Technical Bulletin

Subject: Firmware Release Note: Engine			Prepared by: H.K.		
From: 2nd Overseas Tech Support Sec. 2nd PQM Dept					
Classification:	☐ Troubleshooting	☐ Part informat	tion	Action required	
	☐ Mechanical	☐ Electrical		☐ Service manual revision	
	☐ Paper path	☐ Transmit/rec	eive	☐ Retrofit information	
	☐ Product Safety		vare)	☐ Tier 2

This RTB has been issued to announce the firmware release information for the **Controller.**

Figure 1

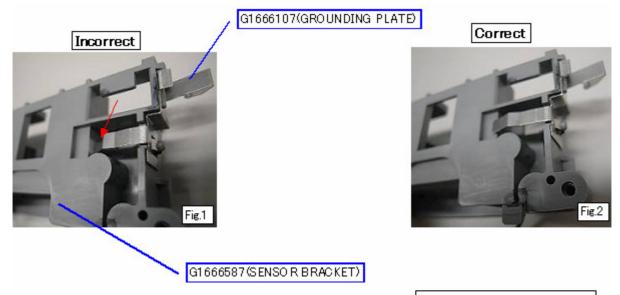
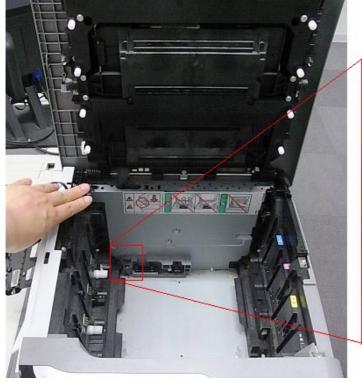
Check for any gap between the holder and mainframe metal plate.

The ITB unit itself may be poorly grounded, so replace the ITB unit.

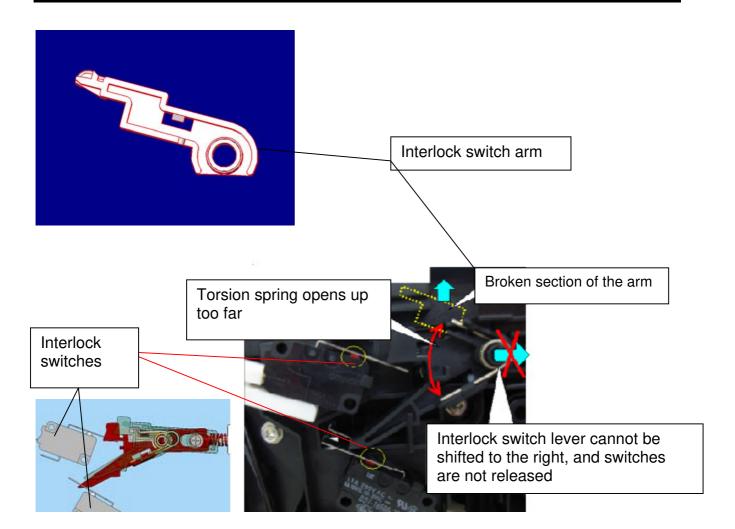
- 1. The "Paper jam" alert message does not clear after jammed paper is removed and the front or top cover is closed.
- 2. The "Toner End" alert message does not clear after the print cartridge is replaced at Toner End. Following this, if the main power switch is turned OFF/ON, the message changes to "Irregular toner".

The interlock switch arm (G1665747) breaks, which causes the torsion spring to open up too far. As a result, the interlock switch lever cannot be shifted and the interlock switches are not released, preventing the machine from detecting the cover open condition.

Replace the interlock switch arm with a new one (G1665754).

The new interlock switch arm (G1665754) is stronger than the previous one (G1665747). Applied from: December 2009 production

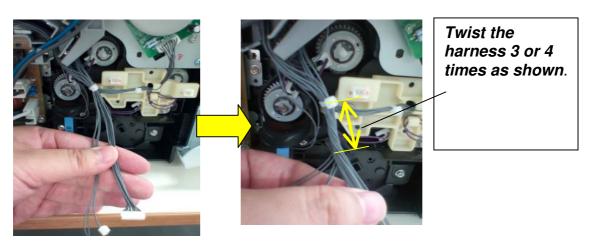
1) Cut the bind of the harness shown below. This is because the harness will be too short when the new parts are attached.

Connect the connectors.

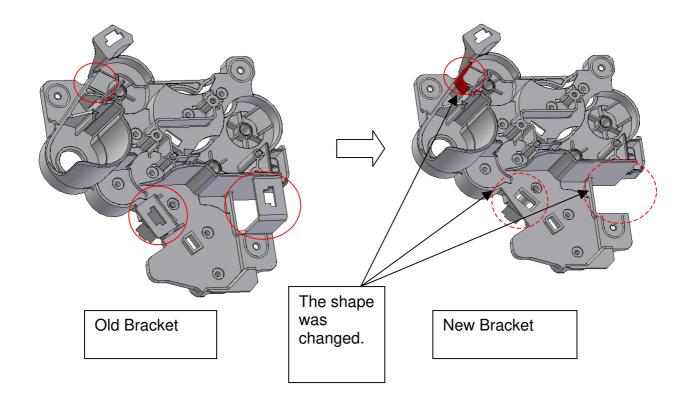
3) Connect the connectors as shown below.

New Harness

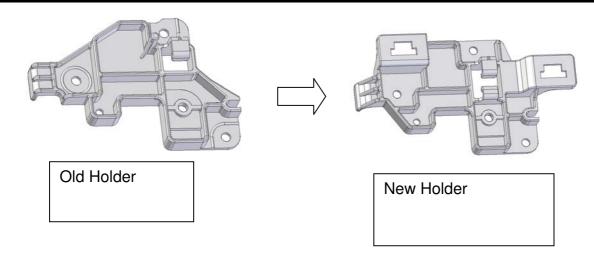
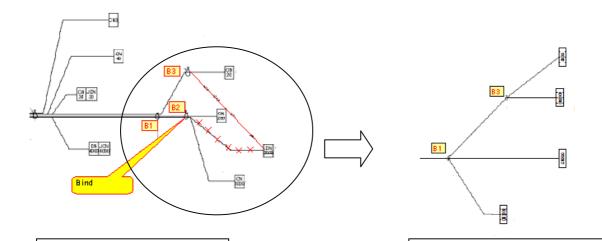
Do the following when you install the new bracket and new holder on old machines:

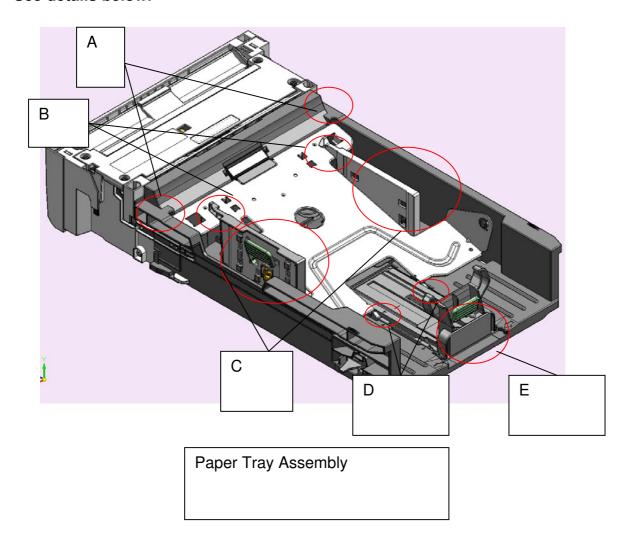
Change: The shapes of the paper tray components were changed.

- 1) To make paper loading easier
- 2) Parts standardization

E: PLATE: END FENCE

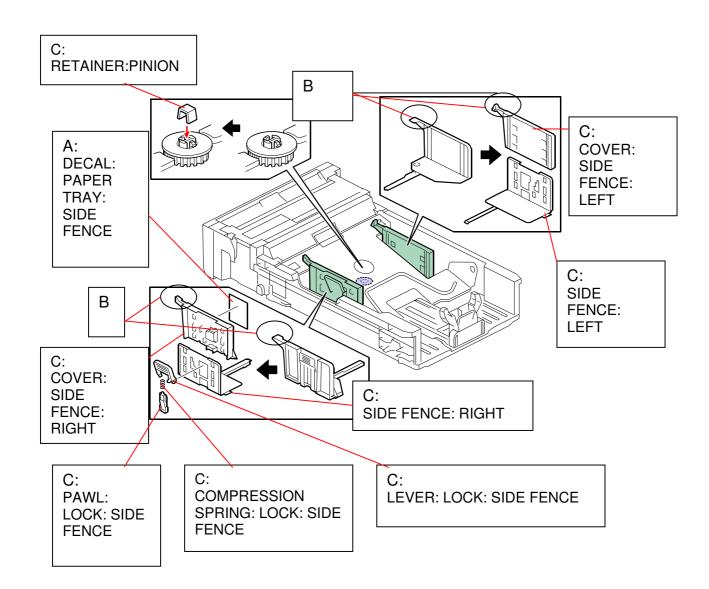
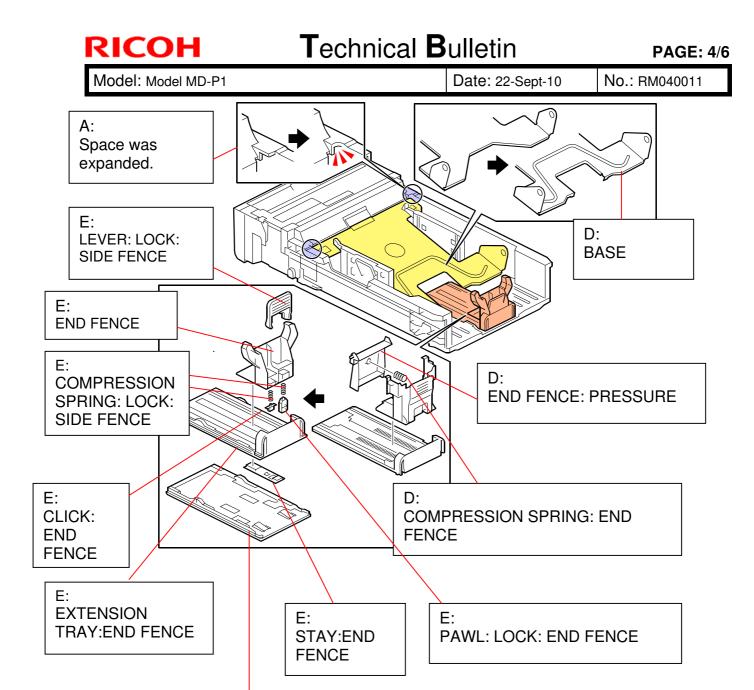
The shape of the end fence was changed (so that it stops at the positions for standard sizes more easily).

Change:

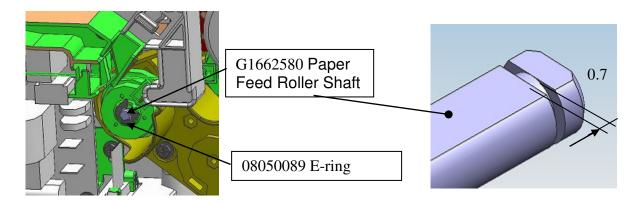
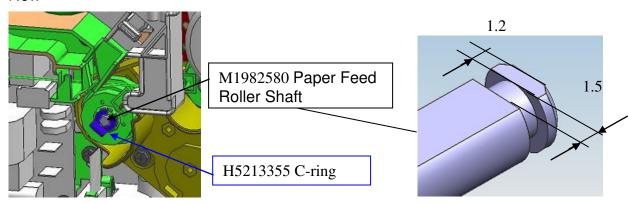
- 1) The width of the e-ring groove in the paper feed roller shaft was increased.
- 2) The e-ring was changed to a C-ring.

Reason: To facilitate assembly.
